Notice of Intent

Sundry ID: 2778457

Type of Action: APD Change

**Procedure Description:** OXY USA Inc. respectfully requests approval to amend the subject well(s) AAPD to update the production string cement from 13.2ppg Class H/Poz slurry to a 13.3 Class C/Poz slurry. See the attached drill plan revision summaries and lab test for reference. No surface hole changes or additional disturbance are related to this sundry.

**UCA Compressive Strength**

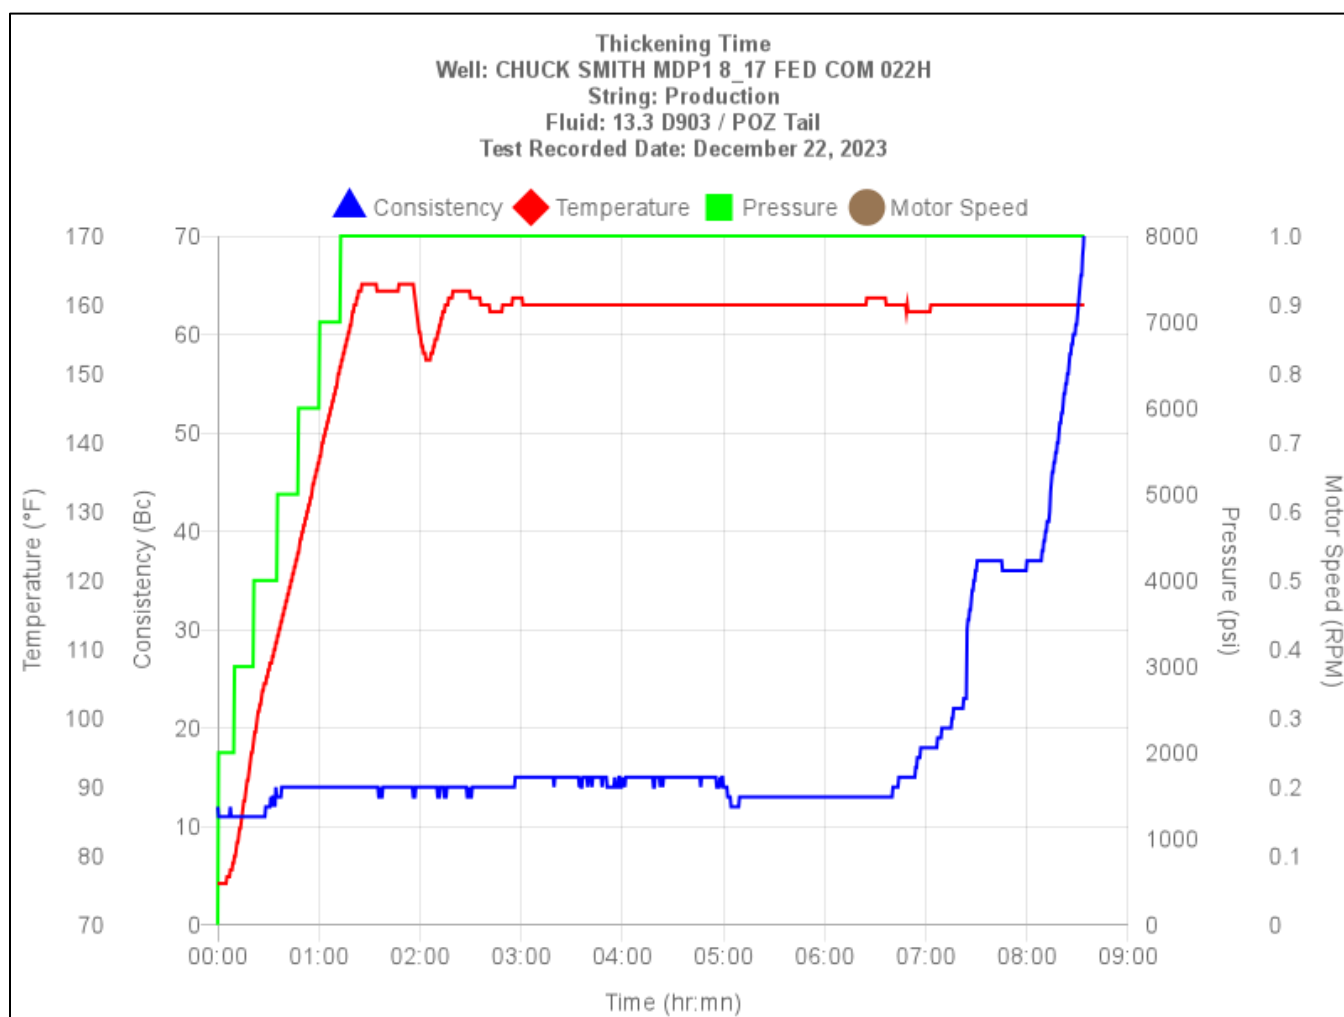
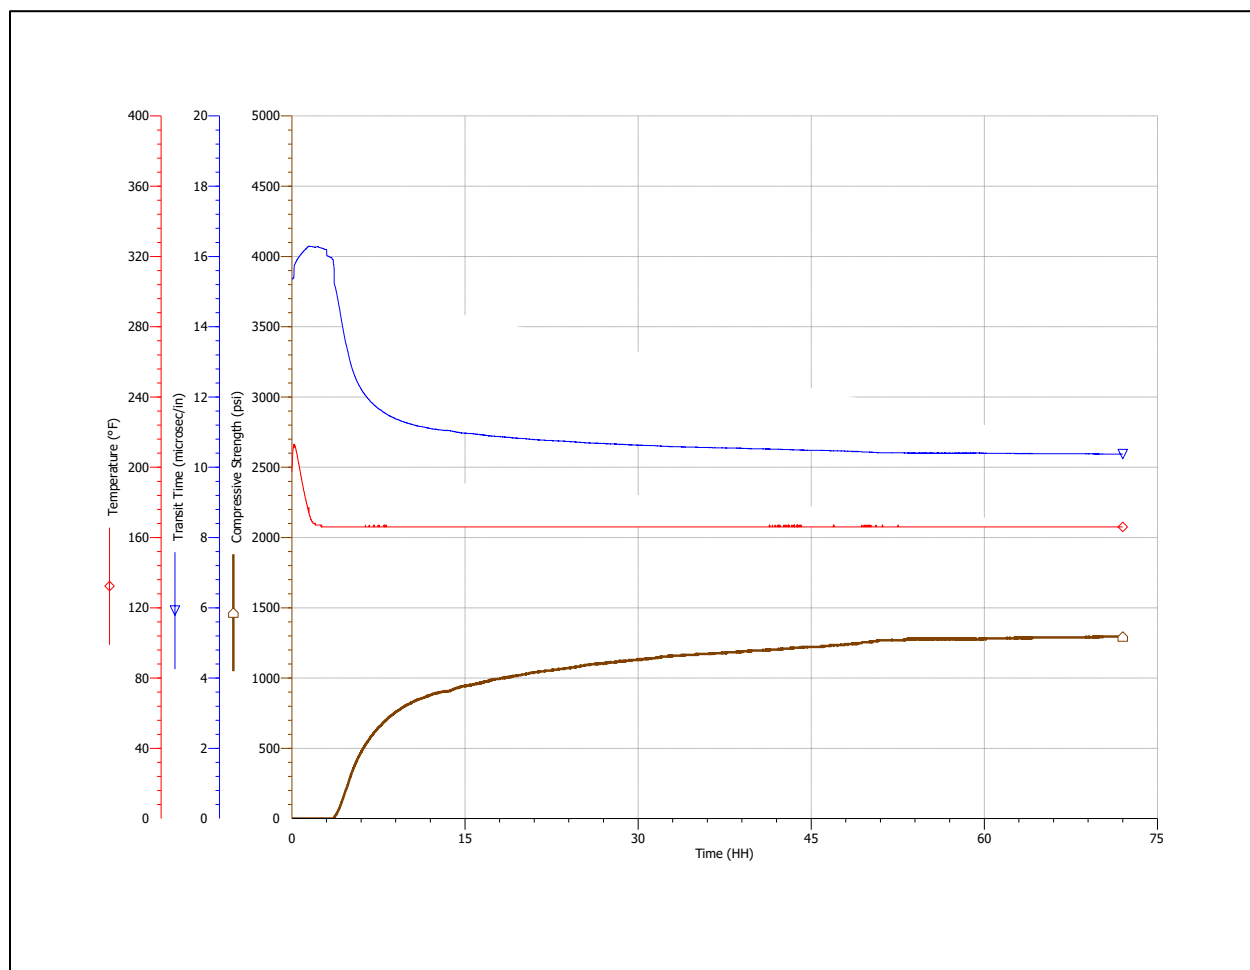
Note: When compared to the Class H / Poz system(s), the Class C / Poz slurry achieved earlier (faster) compressive strength development.

Class H / Poz: 500 psi 13:12 hr:mn

Class C / Poz: 500 psi 06:10 hr:mn

Time	Compressive Strength	Temperature
03:58 hr:mn	50 psi	160 degF
06:10 hr:mn	500 psi	160 degF
24:00 hr:mn	1069 psi	160 degF
48:00 hr:mn	1241 psi	160 degF
72:00 hr:mn	1294 psi	160 degF
Machine S/N:	640
